Agenda
City of Springboro Planning Commission Meeting
Wednesday, June 8, 2022, 6:00 p.m.
Council Chambers, City Building, 320 West Central Avenue

Final Development Plan, The Springs PUD, Planned Unit Development, apartment component

City staff recommends approval of the final development plan subject to compliance with the following comments:

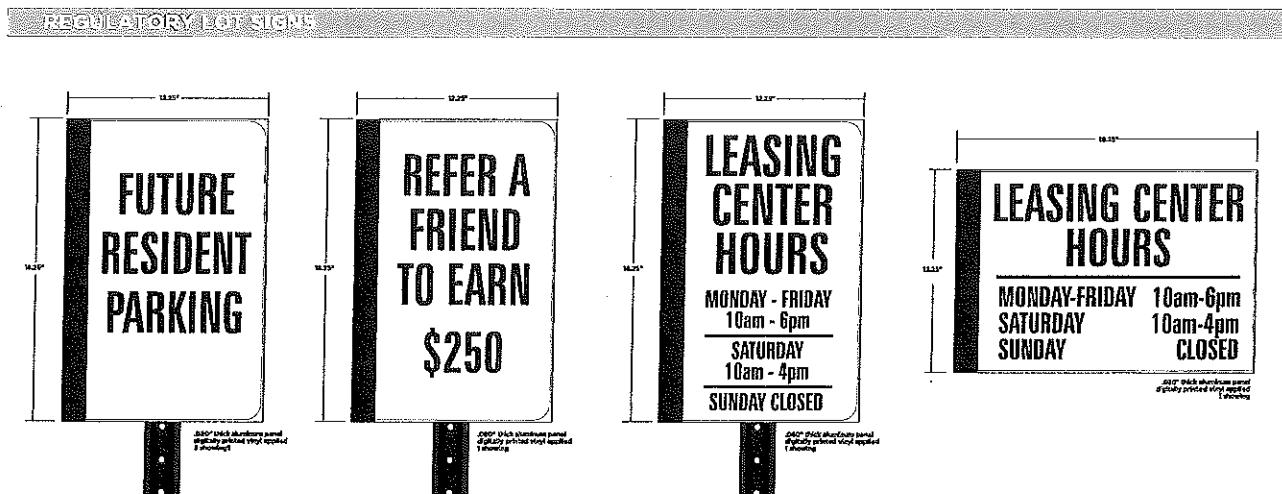
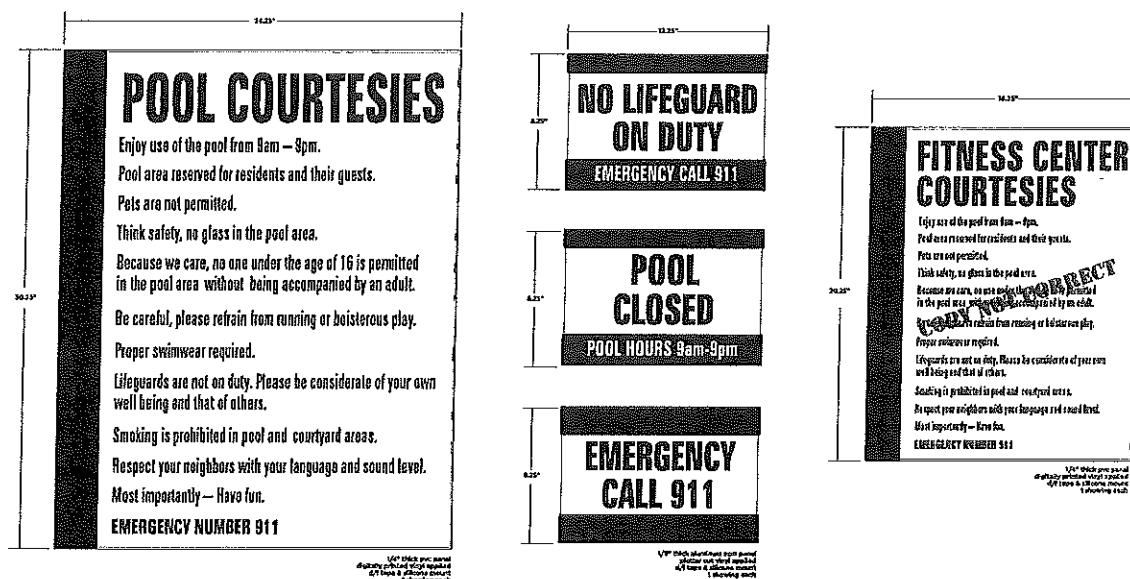
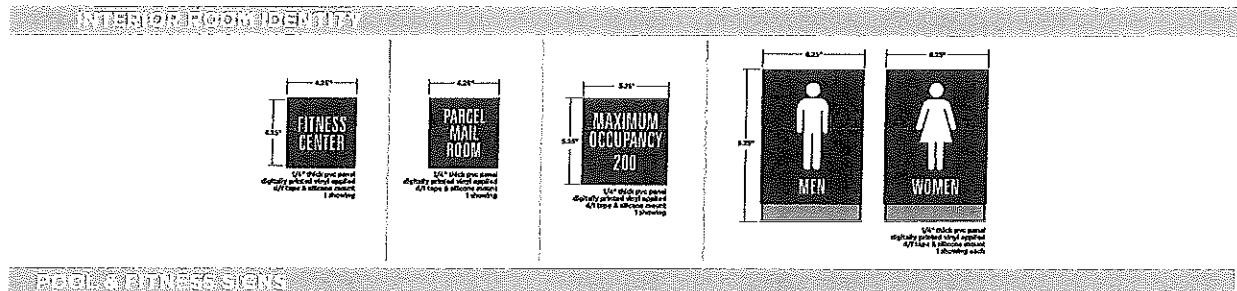
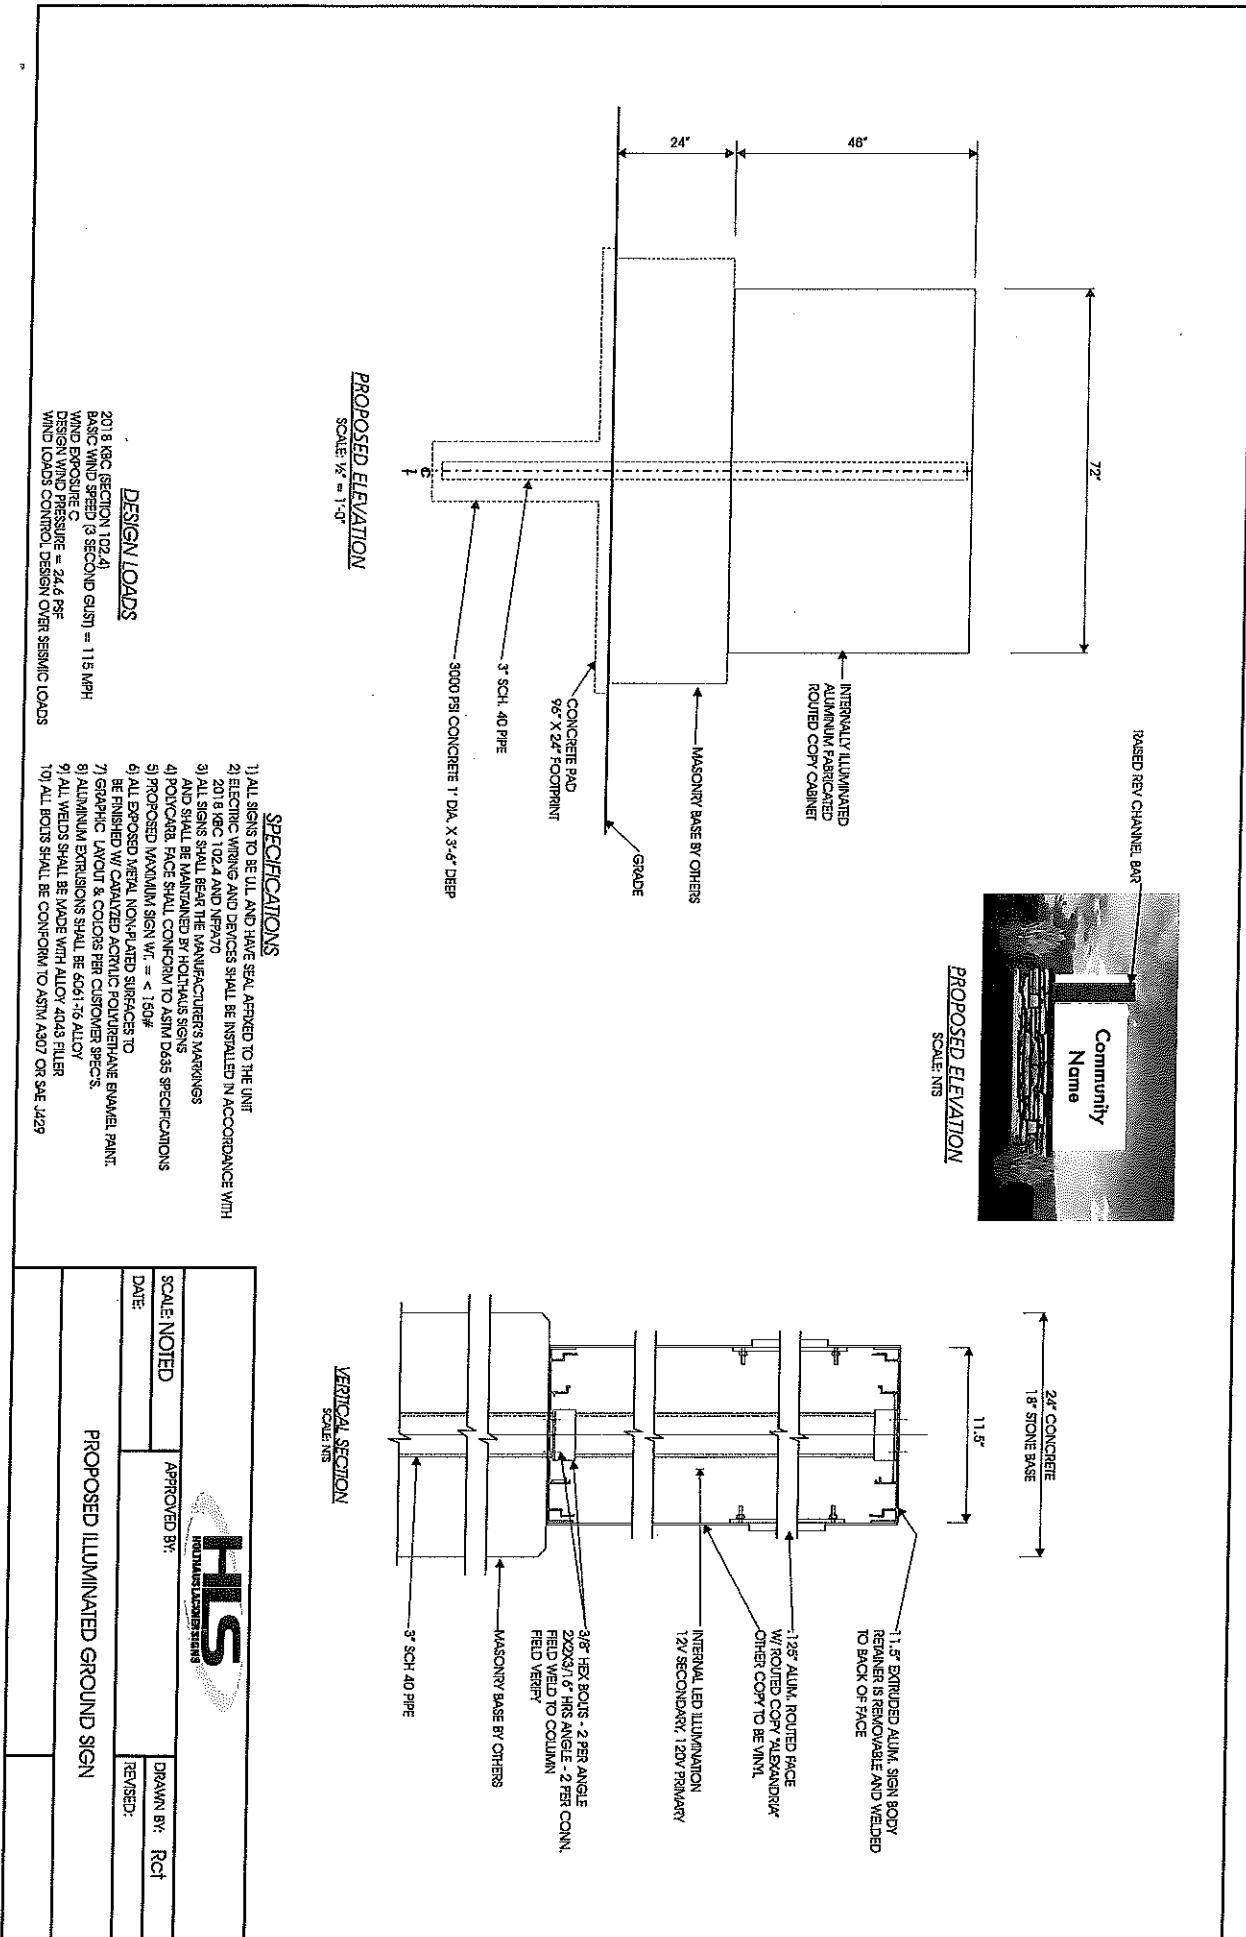
4. Revise landscaping plan for compliance with Chapter 1280, Landscaping, of the Planning and Zoning Code:
 - a. Landscape designer to work with staff to verify location and distribution of plantings satisfying site landscaping requirement.

- b. Increase size of Emerald Green Arborvitae to a minimum of 6 feet.
5. Provide a photometric analysis in foot-candles verifying compliance with Chapter 1273, Exterior Lighting, of the Planning and Zoning Code for parking areas, drives, and walks. Chapter 1273 also applies to architectural lighting including wallpacks.

RSX1 LED

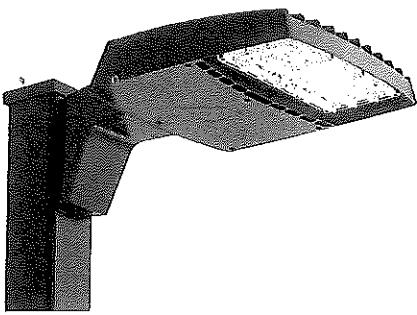
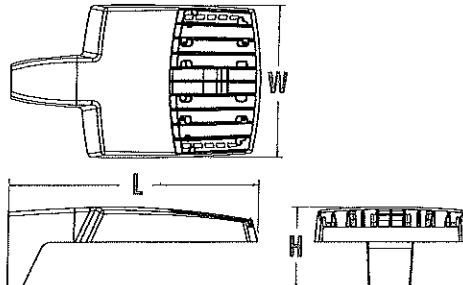
6. Verify proposed lighting complies with maximum 3500° Kelvin color-temperature standard.
7. Manufacturer information for the Lithonia RSX1 lighting is consistent with Chapter 1273 excluding non-horizontal installation included in submitted materials.

Typical Trash Enclosure

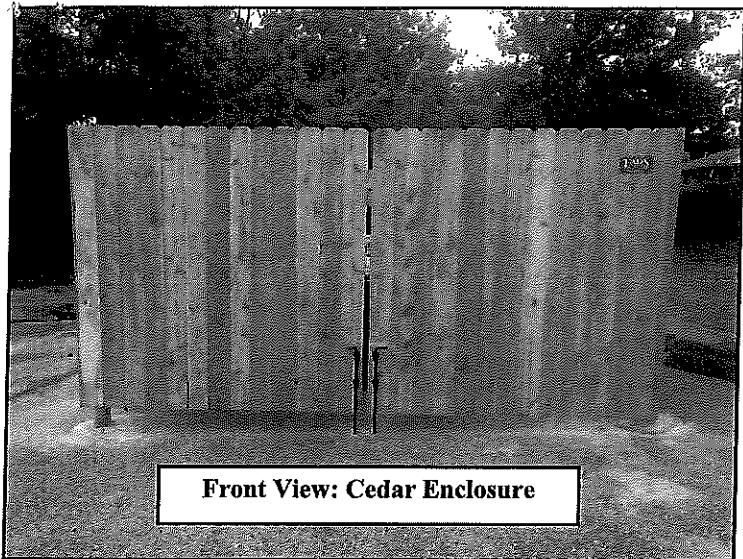
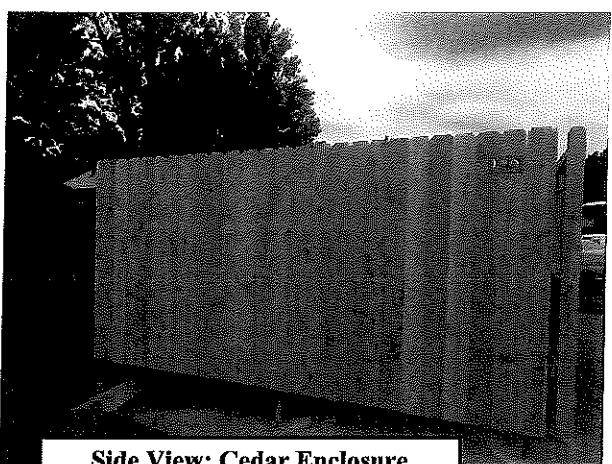
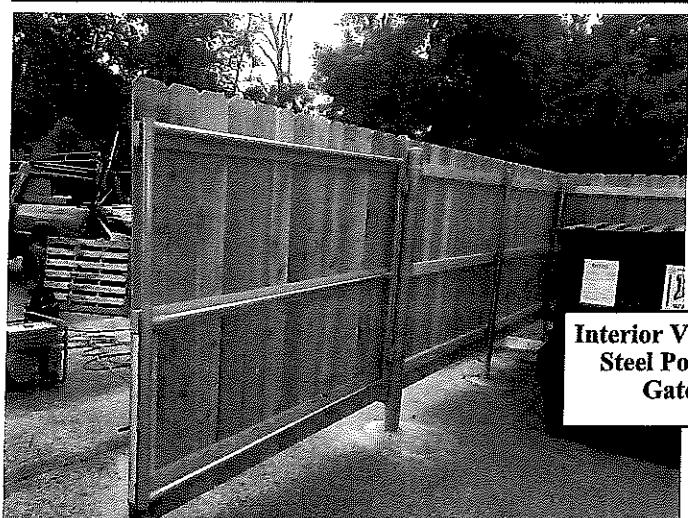
19. Provide street names (private).
20. Provide dumpster enclosure details.
21. Detain the storm water from the existing 42" storm pipe from the east per the original design of the apartment complex.
